PLANNING APPROVAL,
PLANNED UNIT DEVELOPMENT &
SUBDIVISION STAFF REPORT

Date: December 17, 2009

<u>NAME</u>	UMS-Wright Corporation
<u>SUBDIVISION NAME</u>	UMS-Wright Corporation
<u>LOCATION</u>	65 North Mobile Street (Southwest corner of North Mobile Street and Old Shell Road, extending North and West to the CN Railroad right-of-way and the South terminus of Martin Street)
<u>CITY COUNCIL DISTRICT</u>	District 1
<u>PRESENT ZONING</u>	R-1, Single-Family Residential District
<u>AREA OF PROPERTY</u>	1 lot / 51.8 acres \pm
<u>CONTEMPLATED USE</u>	Planning Approval to amend a previously approved Planning Approval Master Plan to allow a new practice field for softball and soccer and new parking area at an existing private school in an R-1, Single-Family Residential District, Planned Unit Development Approval to amend a previously approved Planned Unit Development Master Plan to allow a new practice field for softball and soccer and new parking area, and Subdivision approval to create one legal lot of record.

SITE PLAN

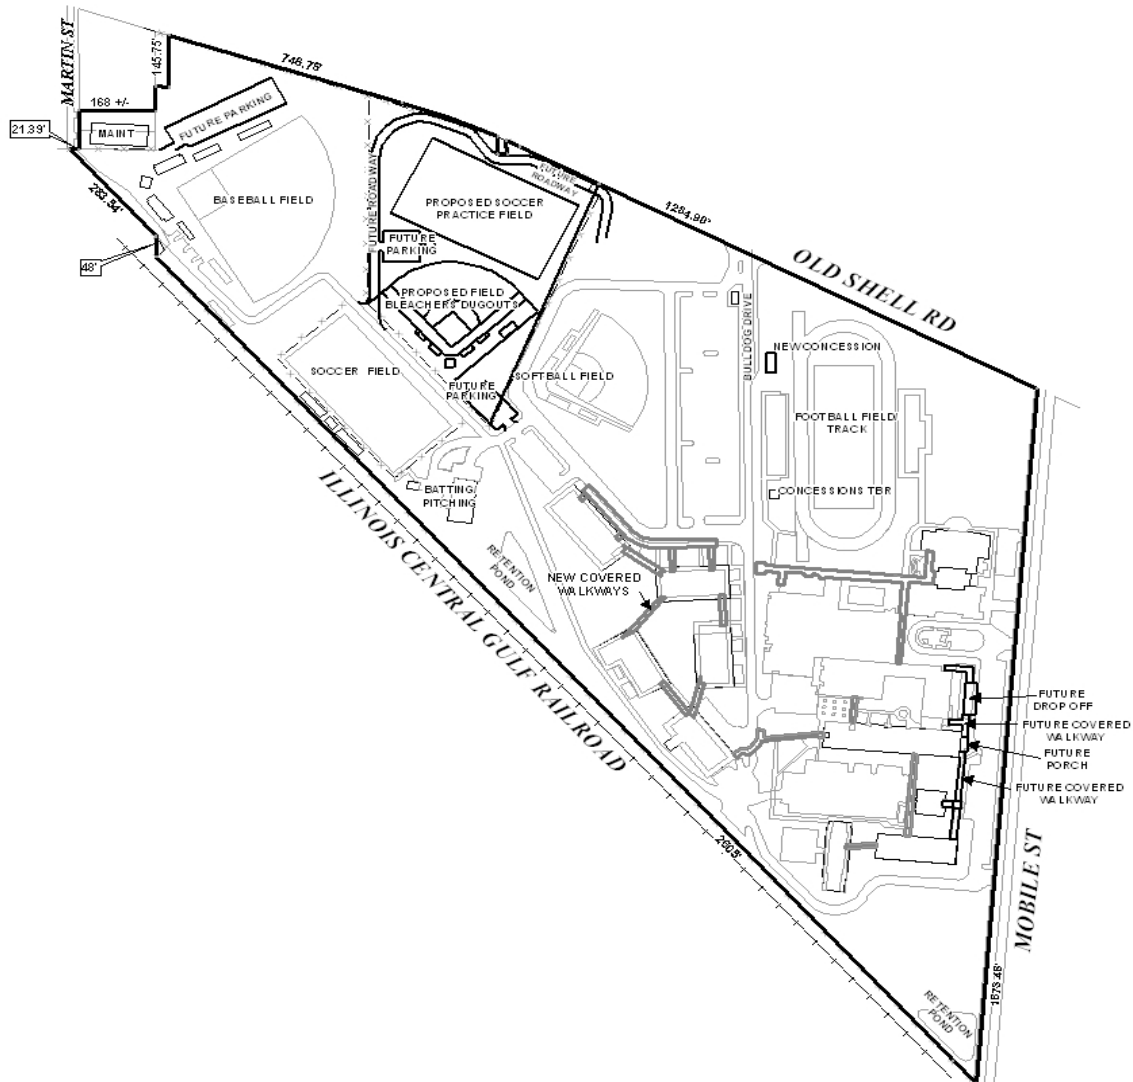
It should be noted that parking on the grass is occurring around the existing baseball fields during games: such parking is not allowed. The site plan should be revised to show the provision of paved parking adjacent to the existing baseball field. All “future” parking areas should be constructed as part of this proposed application, and staff believes that additional paved parking is needed due to the amount of game-time traffic observed at the site.

With regards to site circulation, the site plans illustrates a future parking lot, to which there appears to be no access. Furthermore, the future roadway that encompasses the proposed practice fields has no designated end point, thereby serving no purpose. These are certainly issues that need to be addressed.

The 25-foot minimum building setback line is not depicted on the plat along Old Shell Road within the proposed building site; therefore, the preliminary plat should be revised to show the 25-foot setback line along Old Shell Road within the proposed building site.

- 1) Revision of the site plans to illustrate provision of all “future” and additional parking, access roads, buffers, and site circulation;
- 2) Provision of trees and landscaping to bring the site into compliance with the requirements of the Zoning Ordinance;
- 3) Placement of a note on both site plans stating that lighting of parking facilities will comply with Section 64-6.A.3.c of the Zoning Ordinance;
- 4) Placement of a note on both site plans stating that the site will be in full compliance with screening and landscaping requirements for parking lots to comply with Section 64-6.A.3.i of the Zoning Ordinance;
- 5) Placement of a note on the site plan stating that any changes to the site plan will require new applications for Planning Approval and Planned Unit Development Approval prior to the issuance of any permits; and

- 1) Revision of the site plan to illustrate provision of all “future” and additional parking, access roads, buffers, and site circulation;
- 2) Provision of trees and landscaping to bring the site into compliance with the requirements of the Zoning Ordinance;
- 3) Placement of a note on both site plans stating that lighting of parking facilities will comply with Section 64-6.A.3.c of the Zoning Ordinance;
- 4) Placement of a note on both site plans stating that the site will be in full compliance with screening and landscaping requirements for parking lots to comply with Section 64-6.A.3.i of the Zoning Ordinance;
- 5) Placement of a note on the site plans stating that any changes to the site plan will require new applications for Planning Approval and Planned Unit Development Approval prior to the issuance of any permits; and

- 1) Placement of a note on the plat stating that the development is limited to the existing approved curb-cut along Old Shell Road with the size, design and location of all new or revised curb-cuts must be approved by Traffic Engineering, and should comply with AASHTO standards; and
- 2) Depiction and labeling of the 25-foot setback line along Old Shell Road within the proposed building site.
